**WATER QUALITY CONTROL POLICY ON THE
USE OF COASTAL AND ESTUARINE WATERS
FOR POWER PLANT COOLING**

Final Substitute Environmental Document

**State Water Resources Control Board
California Environmental Protection Agency**

May 4, 2010

Figure 10. 2000-2005 Combined Annual Cooling Water Flow Versus Total Energy Generated by the OTC Power Plants

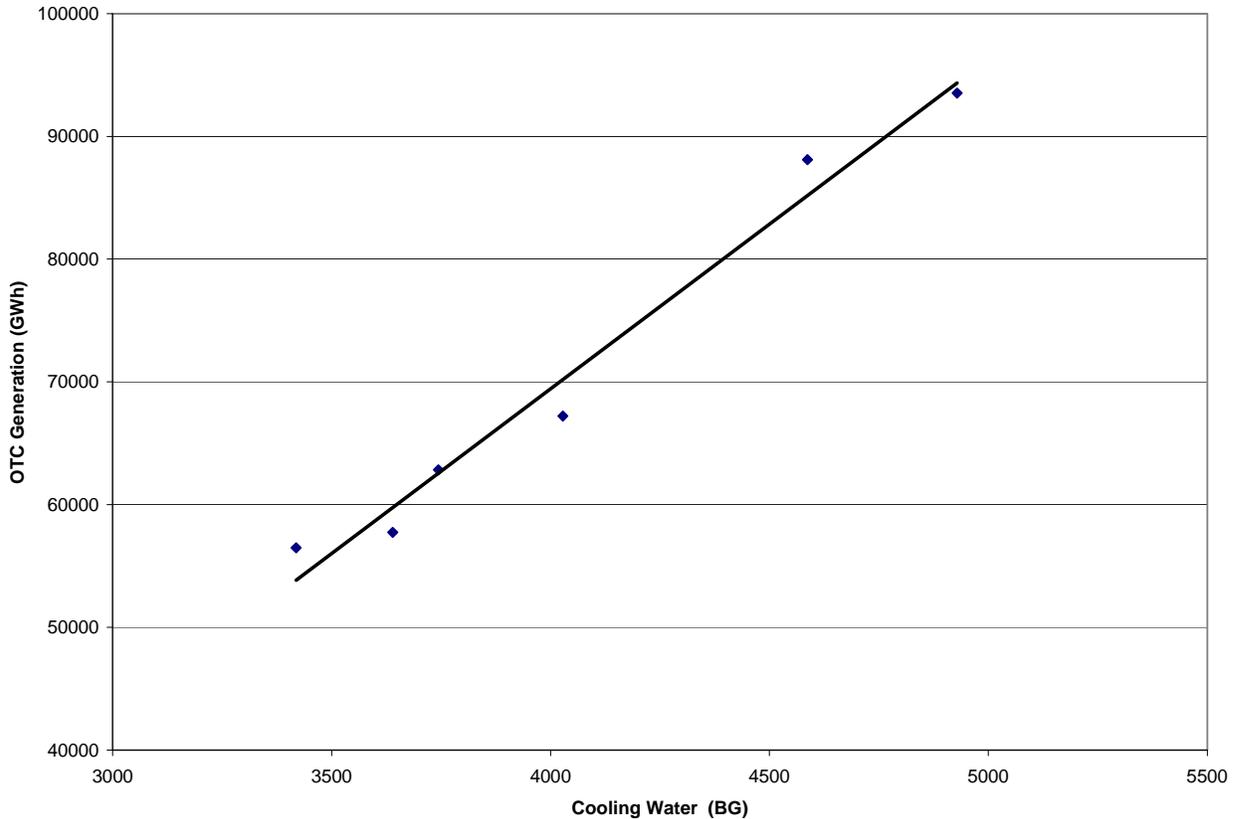
The relationship between cooling water flow and power generation are plotted in Figure 10, but there are only six data points. The statement is made that cooling water flow and power production are linearly correlated. It is unclear why there are only six data points in this graph.

Each data point in Figure 10 represents one of the years from 2000–2005, the period of study that was available when the study was being conducted. Although there are only six data points in Figure 10, each data point shows the combined annual cooling water flows of ALL power plants versus power generation by ALL power plants for that year. The power generated by all OTC power plants in each of the six years is represented by a point on the Y-axis in Figure 10. This is the same value that is shown in Table 10 under the row heading of “Gross OTC Power Produced (GW/h).” For example, the first point in Figure 10 corresponds to power generation in 2005.
